**Public Meeting Tuesday August 29, 6 PM to 7:30 PM**  
**at Webster School (Currently the Nordic Heritage Museum) (3014 NW 67th Street)**  
**Webster School Renovation and Addition Project**  
**(comments due by 5 PM, Thursday Sept. 7) Comment *right away* on the**  
**Environmental Checklist – ask for an EIS / Environmental Impact Statement!**

REGARDING: Comments on Draft SEPA Environmental Checklist for the Webster School Renovation and Addition Project (3014 NW 67<sup>th</sup> Street), as posted on the School District website at <http://sepa.www.seattleschools.org/sepa>

Attached are some comments on the Draft SEPA Checklist (State Environmental Policy Act) for the Webster School Renovation and Addition Project (3014 NW 67<sup>th</sup> Street).

Path: \\sps\apps\projects\SEA\1\boxx\160418.02 SPS Webster Elementary\05 Figures\Photos\Figures\Fig. SitePlan.pdf, JAB, 05/07/2017

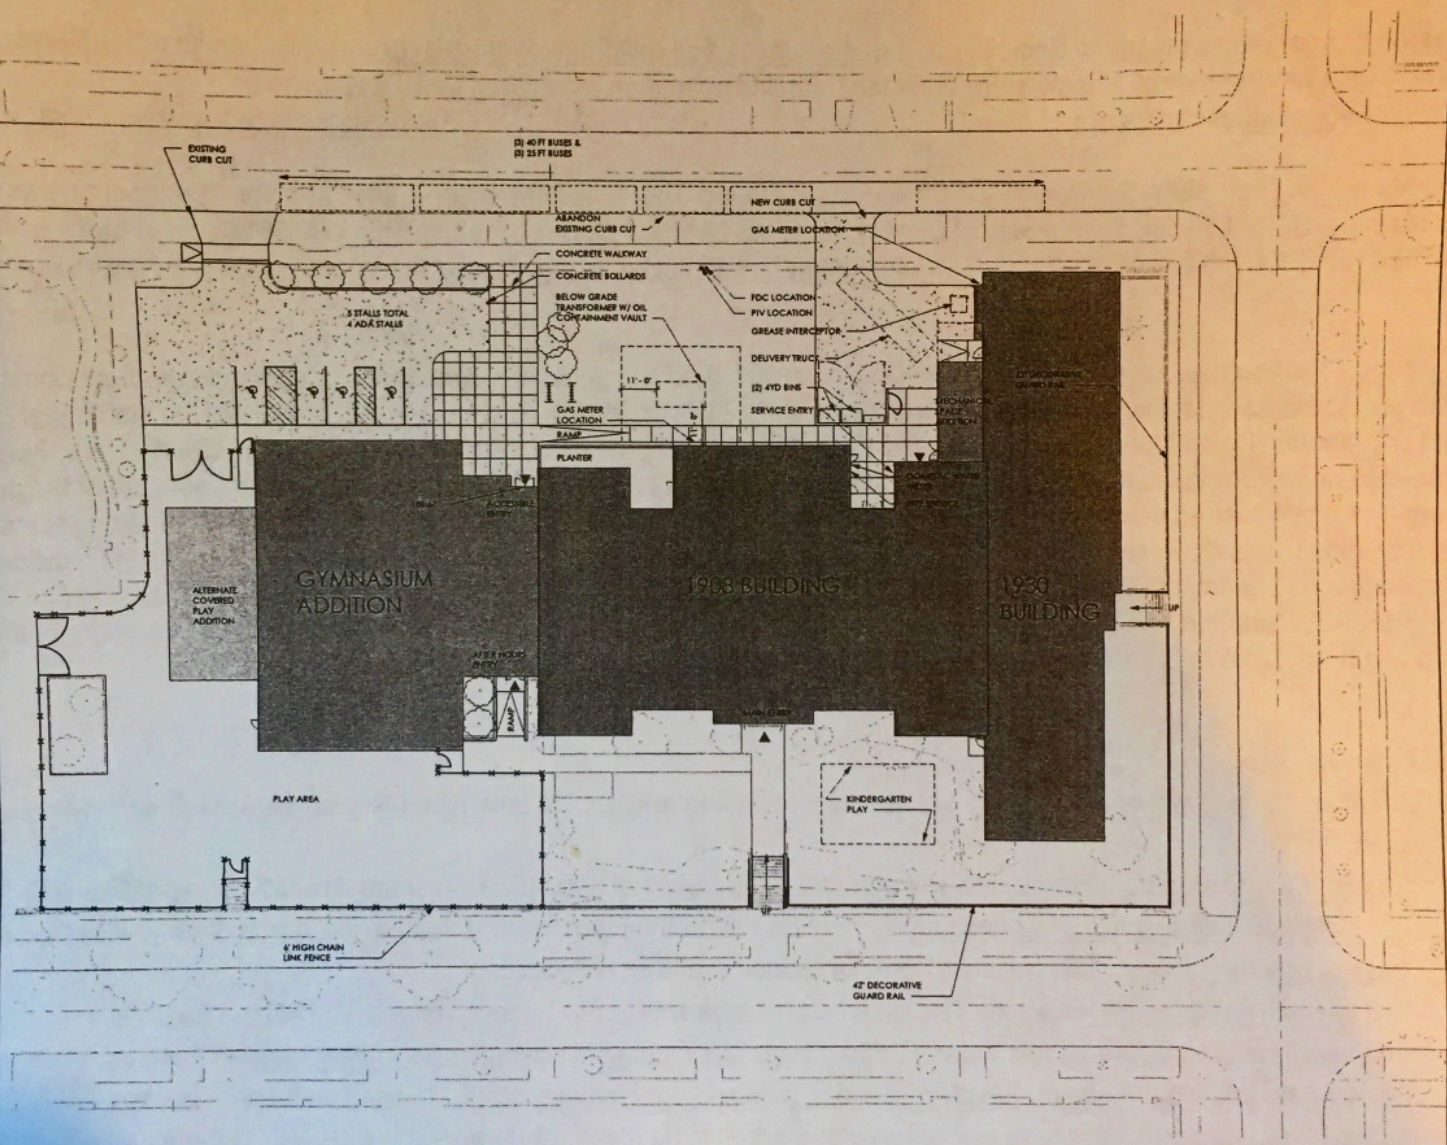
- F. Constructing new buildings on the playground (a gym and covered play area). It would be better to restore rather than demolish the (pre-museum) gym and covered play area inside the north portion of the school. Otherwise, construction on the playground causes loss of playground space and blocks use of the playground for event parking and for bus loading and puts these impacts out into the neighborhood (NW 67<sup>th</sup> and NW 68<sup>th</sup> adjacent to the school would be school-bus and passenger-vehicle load / unload zones).

- c. Before the school was remodeled for museum use, the north side of the school held a covered play area (west side) and gym. An EIS could examine the alternative of restoring the original gym and covered play area, rather than demolishing them (see Figure 3, Site Plan).
